Office Action Summary	Application No. 10/773,135	Applicant(s) SITISO ET AL.	
	Examiner Mary Hoffman	Art Unit 3733

DETAILED ACTION

US 6,723,100 B2

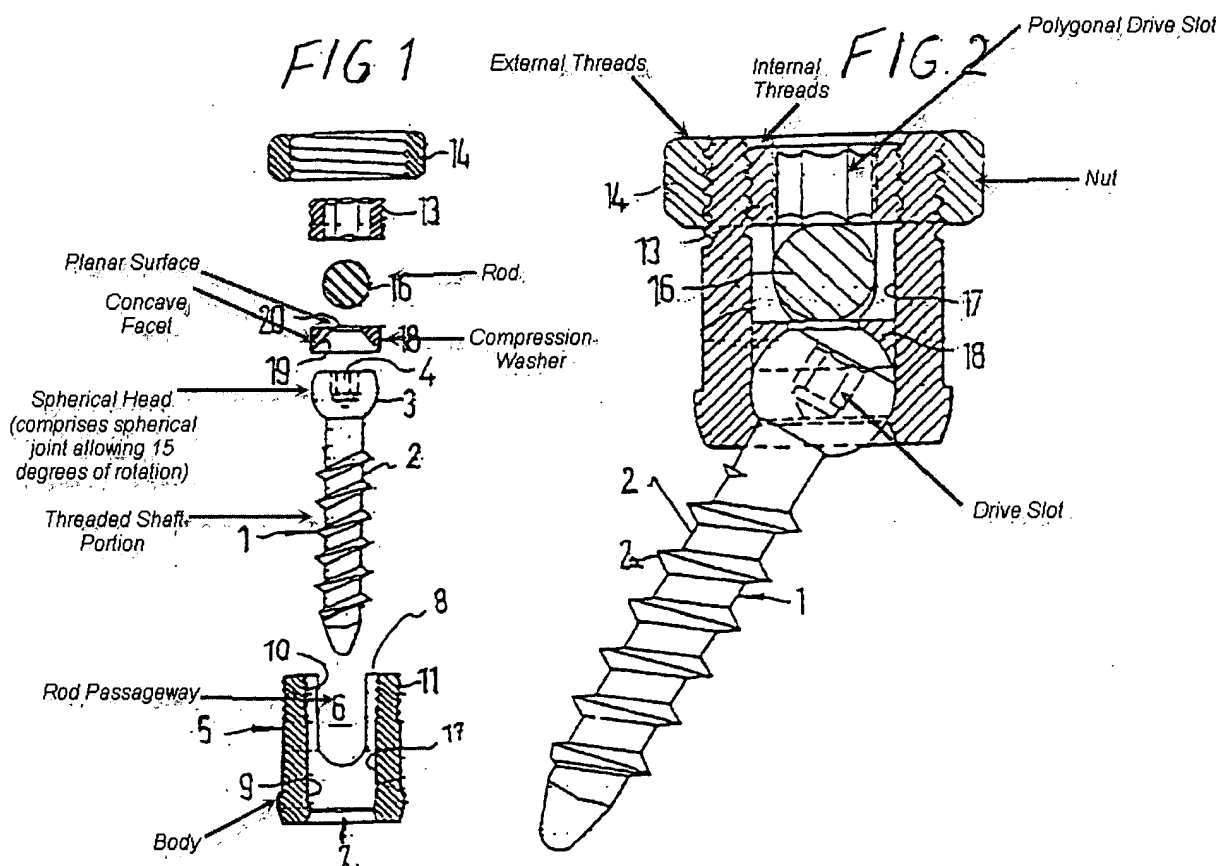
Biedermann et al. disclose various embodiments of a pedicle screw assembly comprising a pedicle screw having a head portion and a threaded shaft portion extending from the head portion, and a body having an aperture, a rod passageway, and oppositely threaded internal and external threads. The set screw has exterior threads for engaging the internal threads of the body and a nut having internal threads for engaging the external threads of the body. The head portion of the pedicle screw includes a rounded head, and the head and base form a spherical joint. A compression washer is disposed in the base for retaining the head of the pedicle screw within the base. The compression washer is press-fit within the base and includes a concave facet disposed above the head of the pedicle screw. The threaded portion of the pedicle screw is tapered. The assembly of pedicle screw includes a drive slot formed in the head portion. The rod passageway and the pedicle screw aperture of the body are transverse to one another. A rod extends through the rod passageway. The set screw is capable of traveling within the body and contacting the rod, securing it in place within

the body. The set screw includes a drive slot therein for tightening by a driver device. The assembly of nut has a polygonal outer configuration. The set screw and nut are fastened in opposite directions. Biedermann et al further disclose a spinal fixation system comprising a plurality of pedicle screw assemblies, and a rod extending between the pedicle screw assemblies. The system pedicle screw includes a drive slot formed in the head portion. The compression washer defines a generally planar surface on the upper surface facing the rod assembly. A tightening device is disclosed for simultaneously tightening the set screw and the nut, comprising a wrench with a handle, and a driver with a handle. The wrench has a shaft and socket, and the driver has a shaft slidably extending through the wrench. The driver has a driver end. (See marked-up figures below).
